Re: Stormwater Management **CONCEPT** Request
for Jordan & Smith Addition to Silver Spring
Preliminary Plan #: Pending
SM File #: 210991
Tract Size/Zone: 0.48 Ac./CBD-2
Total Concept Area: 0.48 Ac
Lots/Block: 30/1
Watershed: Lower Rock Creek

SUBJECT: Stormwater Management Concept Plan/100-Year Floodplain Review
Site Plan # 8-05004, The Crescent
Project Plan #
Preliminary Plan # 1-89288A, DPS File # 210991
Subdivision Review Meeting of September 20, 2004

SUBJECT: Plan # 1-89288A and 8-05004, Name Jordan and Smith's Addition/The Crescent
DRC date: September 20, 2004

SUBJECT: Site Plan Review No. 8-05004
Preliminary Plan Review No. 1-89288A
The Crescent (930 Wayne Avenue)

Attachment A- Map 35 Residential Downtown

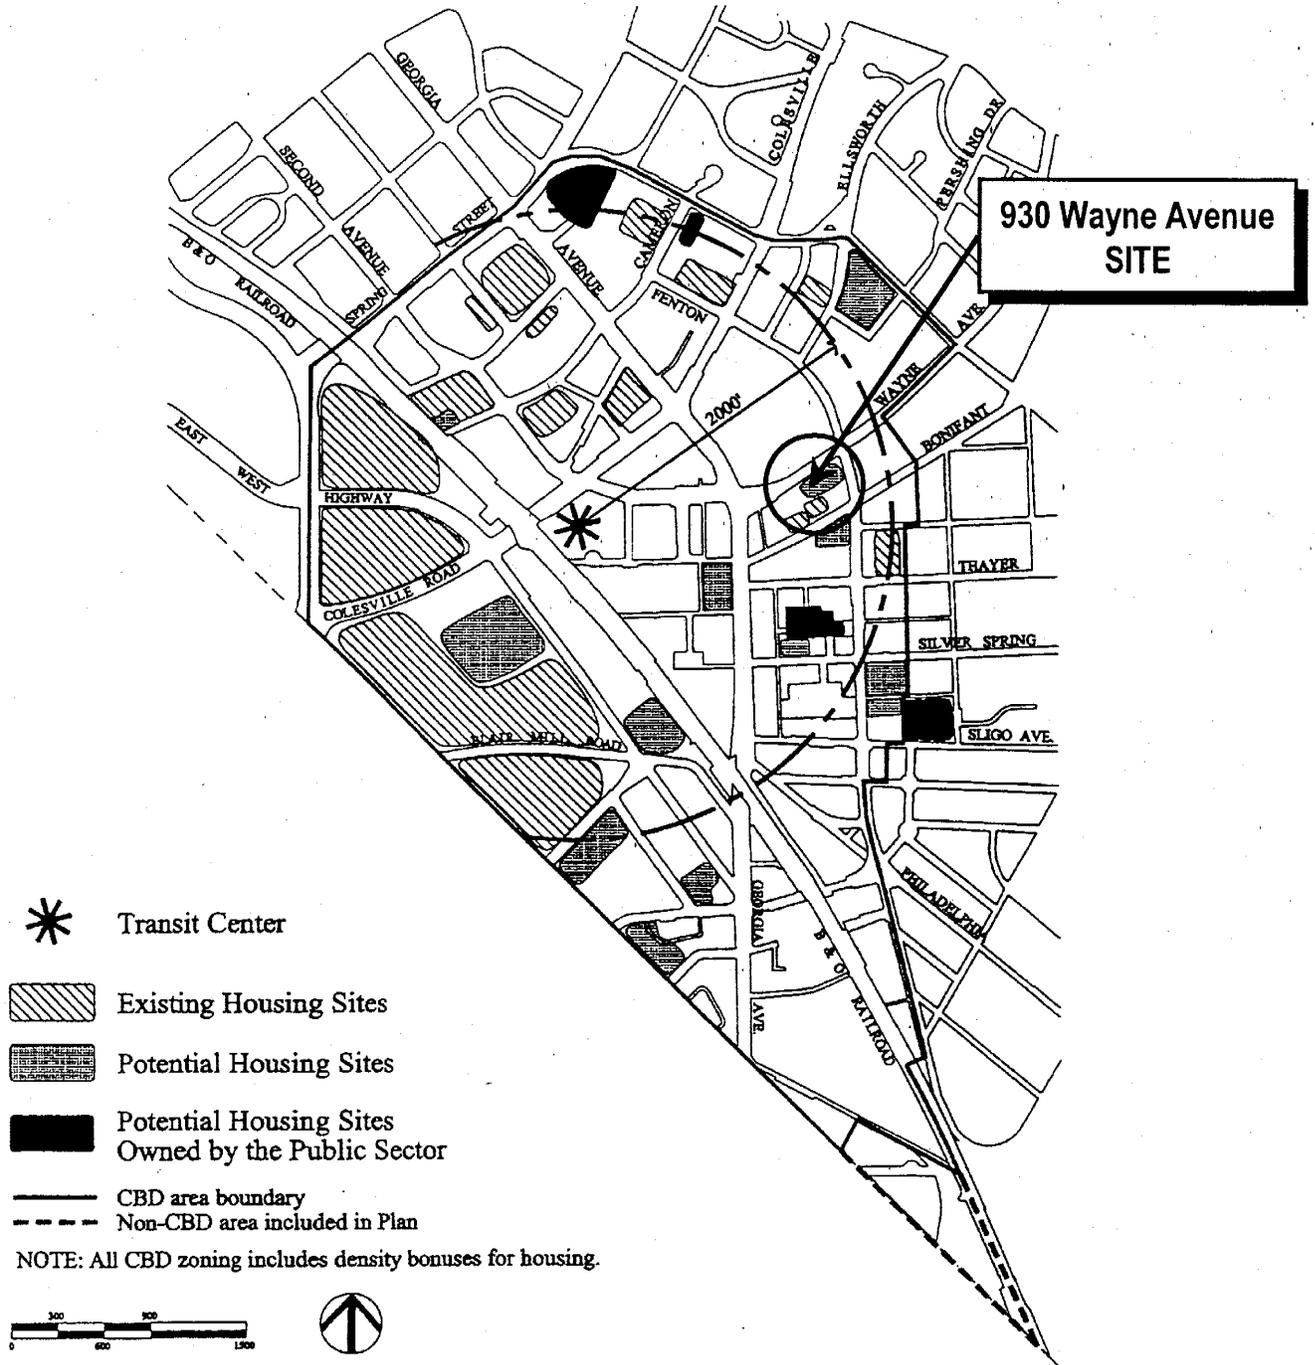
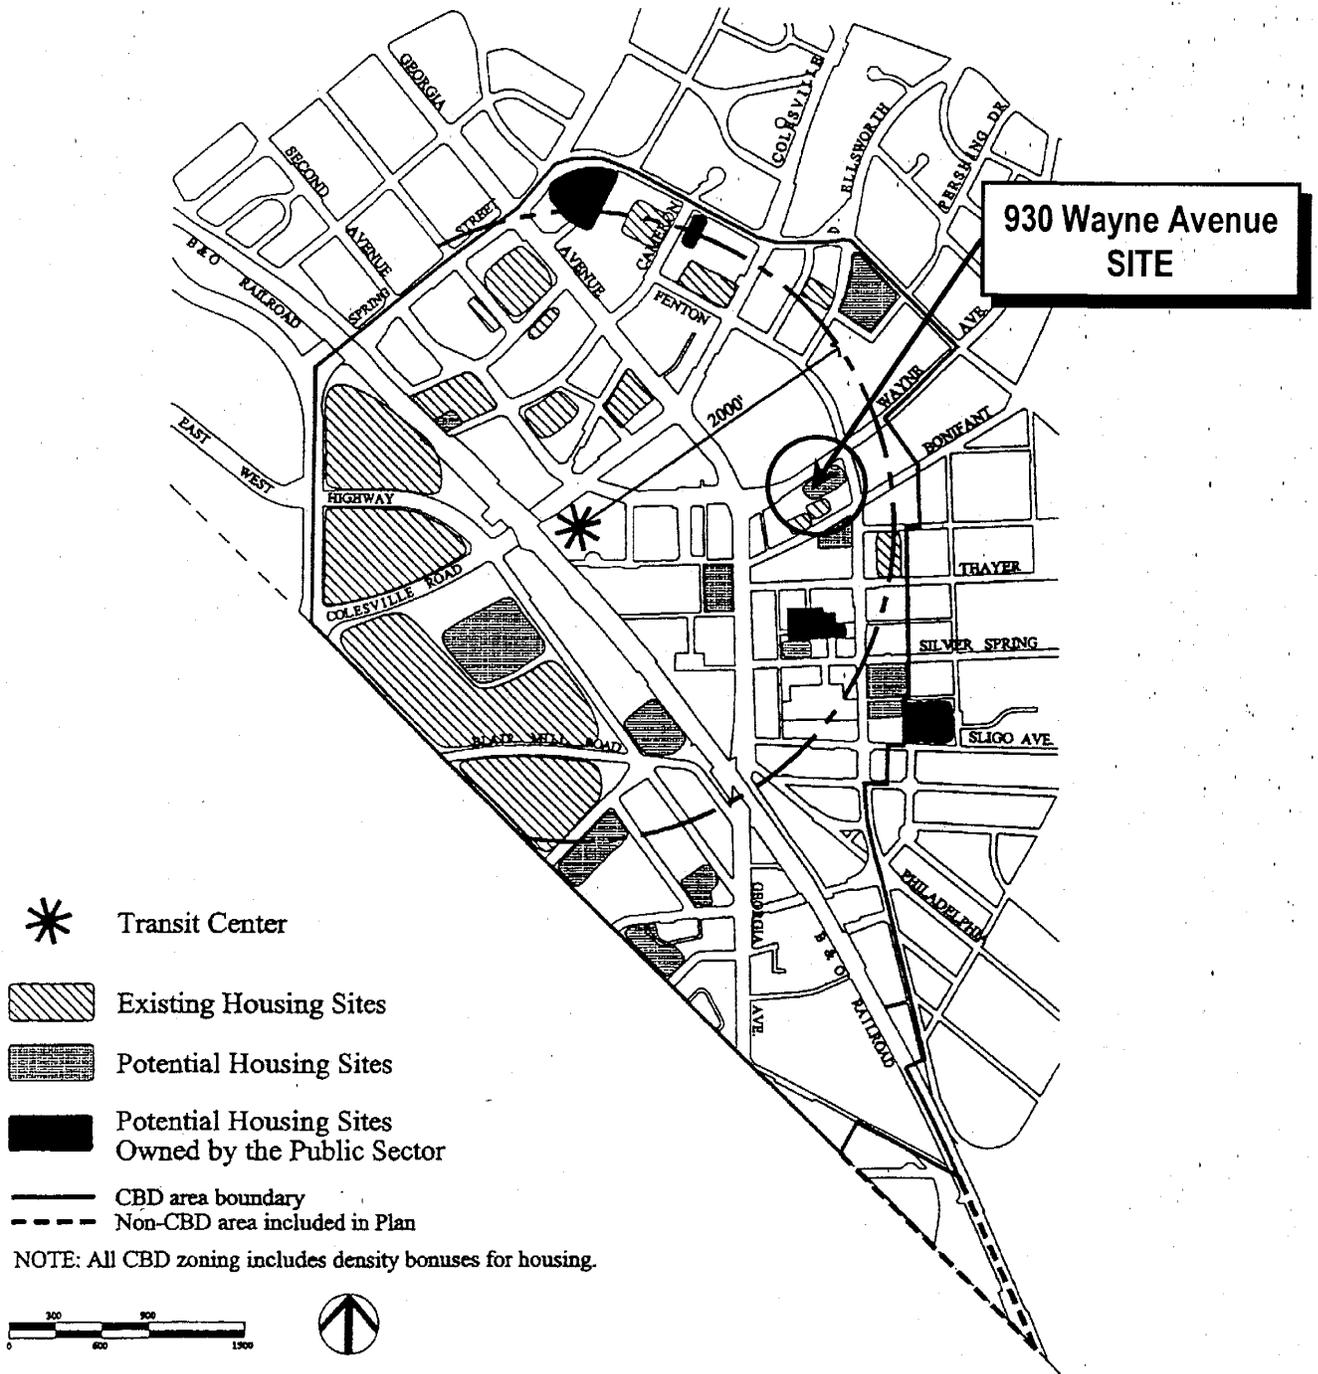
The proposed mixed-use development is comprised of 143 residential units and 1,740 square feet of retail space which are permitted uses under the CBD-2 zone. The Sector Plan specifically identifies this property as a potential housing site (see **Attachment A-Map 35 Residential Downtown**). The proposal will be implemented under the optional method of development. The project proposes 150,993 GSF (gross square feet) of development (149,252 GSF of residential and 1,741 GSF of non-residential) with a 5.0
